Date of Issue: September 2018

Affected Publication: API Specification 20A, Carbon Steel, Alloy Steel, Stainless Steel, and Nickel Base Alloy Castings for Use in the Petroleum and Natural Gas Industry, Second Edition, August 2017

## Addendum 1

Figure 4—Equivalent Round Models—Keel Block Configuration

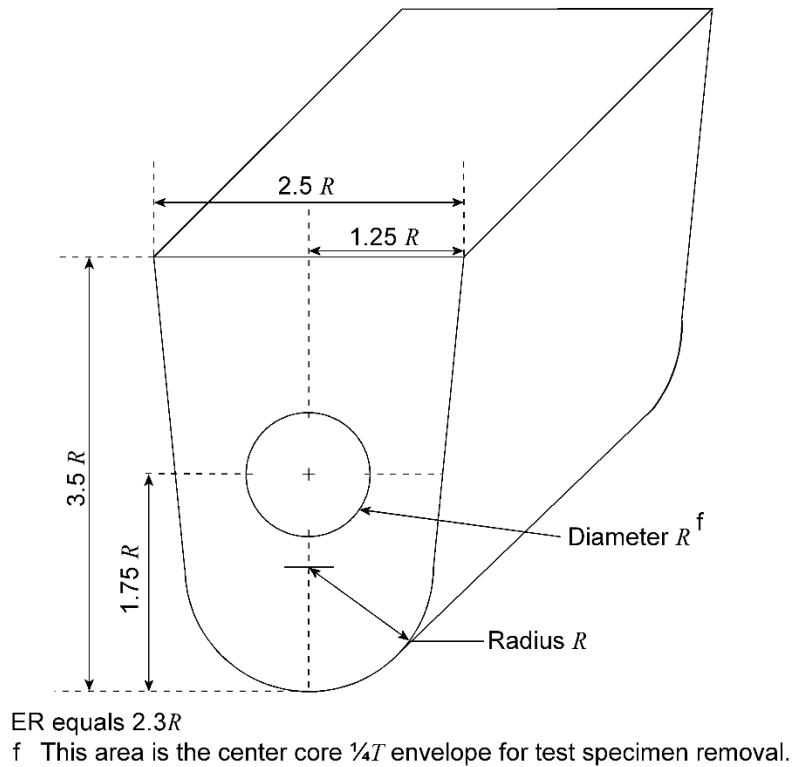
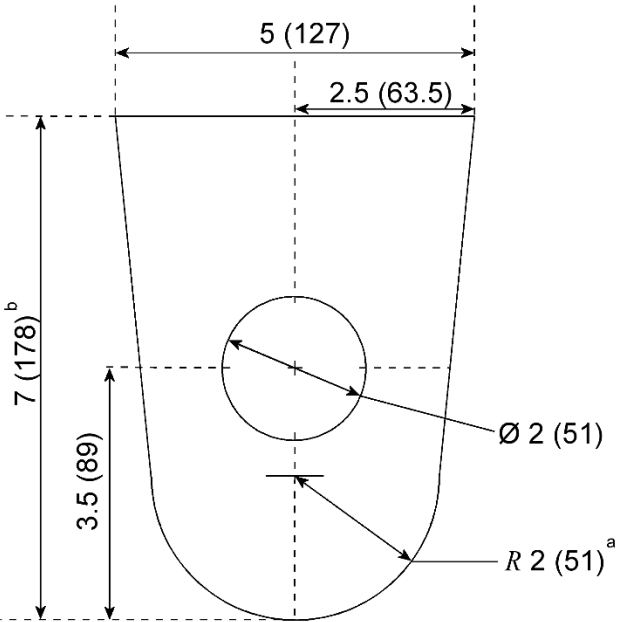
Page 10: Figure 4 shall be replaced with the following:
